108 Bellara Drive,  
CROYDON  
VPP2402812 –  
Consent under  
Clause 52.20

Consent under Clause 52.20 Officer Assessment  
Development Approvals & Design

Department  
of Transport  
and Planning

Figure 10: Floor plans of the dwellings

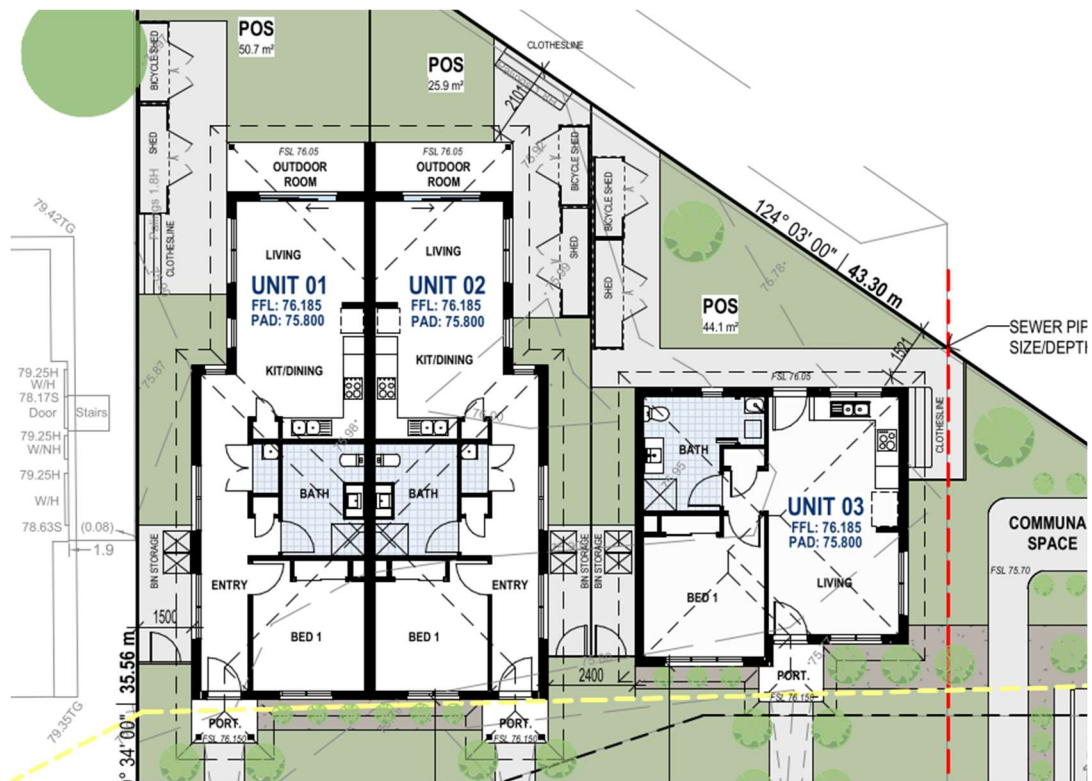
44. The dwellings are all sited to face the street, with dwellings 1 and 2 separated by a party wall. Dwelling 3 is a stand alone dwelling.
45. The dwellings are located to the rear of the property, the triangular shape and the significant width of the overlay across the front of the property restricts the available space for the construction of dwellings on the site.
